Subject: Supplemental Geotechnical Engineering Services
Laban Residence Improvements
10 Brook Bay Drive
Mercer Island, Washington 98040

Per your request, this supplemental report provides revised geotechnical design recommendations for the permanent shoring walls and pipe pile foundation support in response to design changes and City of Mercer Island plan review comments. This report is considered supplemental to and should only be used in conjunction with our 27 February 2023 geotechnical report referenced above.

Laban Residence Improvements
ZGA Project Number: 2560.01
September 18, 2023

PIN PILE AND SHORING PLAN

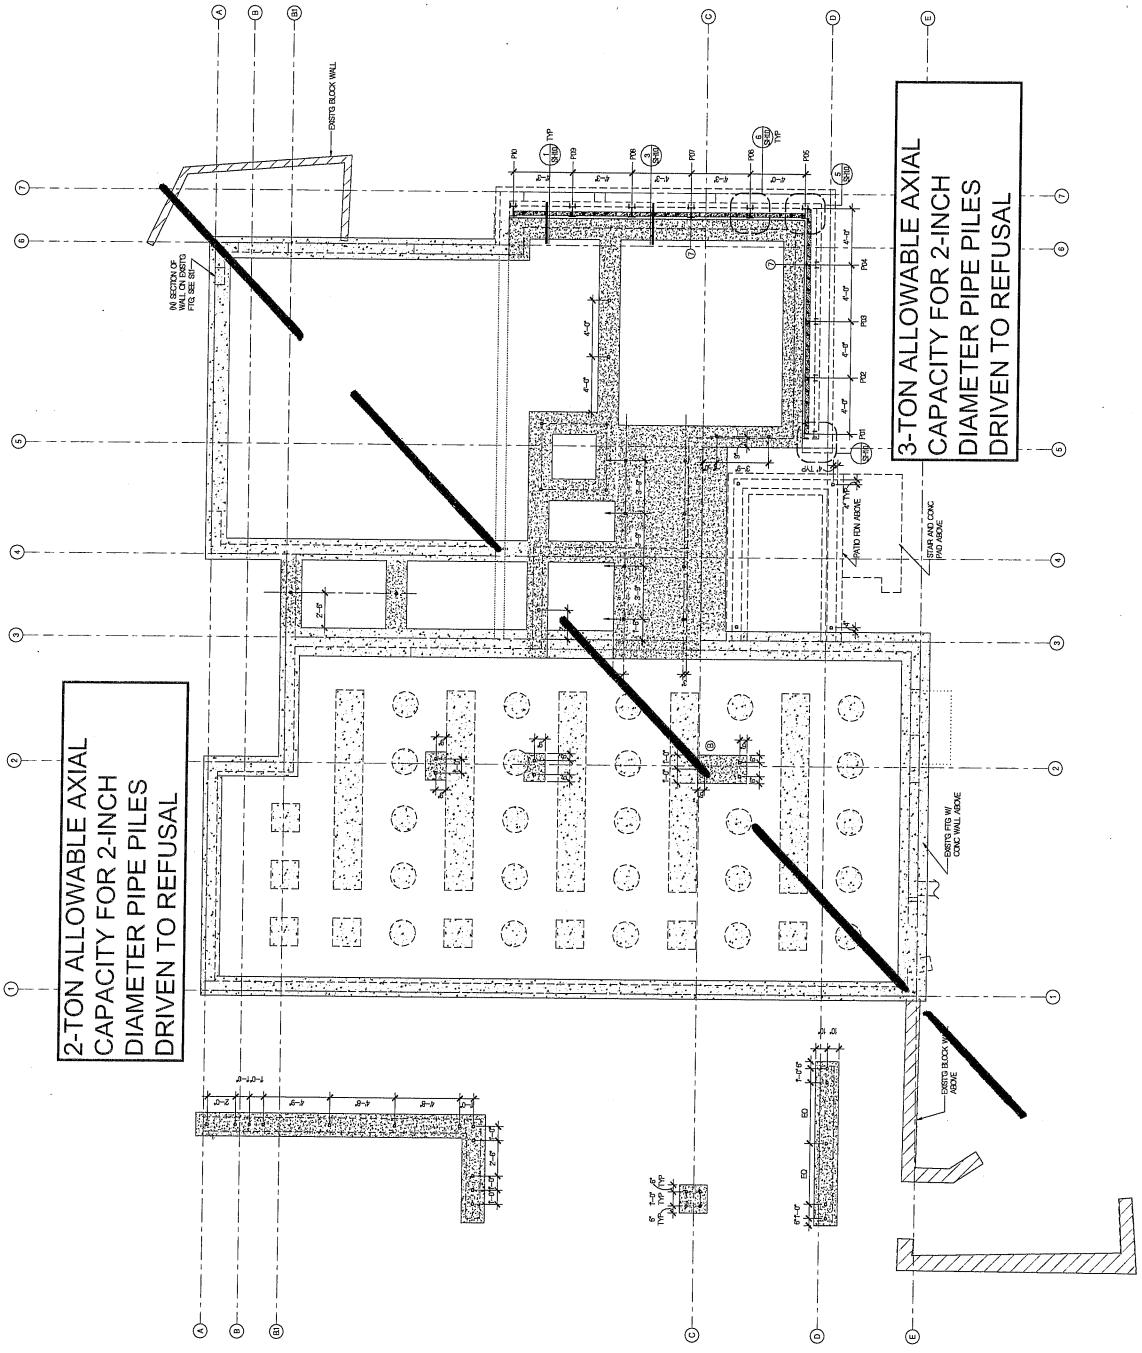
Section 3.8.1 of the 27 February 2023 geotechnical report recommends an allowable axial compressive capacity of 3 tons per pile for 2-inch diameter pipe piles driven to refusal. We understand that City of Mercer Island plan review comments suggest that the standard of practice in this region is to limit the axial capacity of 2-inch diameter pipe piles to 2 tons per pile in liquefaction and peat hazard areas, presumable due to pile bucking concerns. Section 3.2 of our 27 February 2023 geotechnical report addresses City of Mercer Island geologic hazard areas and identifies the relatively level northwestern portion of the site (northwest of the site slope) as a seismic hazard area with the potential for liquefaction during the 2018 IBC design earthquake. To address the City review comment, we recommend that 2-inch diameter pipe piles located in the northwestern portion of the building be designed for an allowable axial capacity of 2 tons per pile while 2-inch diameter driven pile piles located in the southeastern portion of the building (beyond the limits of potential liquefaction) be designed for an allowable axial capacity of 3 tons per pile. Exhibit A enclosed with this letter presented our recommended transition line from 2 ton to 3 ton piles and is based on geotechnical borings B-1 through B-3, groundwater data, and site topography. We anticipate that total and differential static and seismic settlements for foundations supported on pipe piles design and installed as recommended herein and our 27 February 2023 geotechnical report will be on the order of ½ inch or less. Most of the settlement is expected to occur rapidly as loads are applied. Post construction differential settlement should be minor.

2-TON ALLOWABLE AXIAL CAPACITY FOR 2-INCH DIAMETER PIPE PILES DRIVEN TO REFUSAL

3-TON ALLOWABLE AXIAL CAPACITY FOR 2-INCH DIAMETER PIPE PILES DRIVEN TO REFUSAL
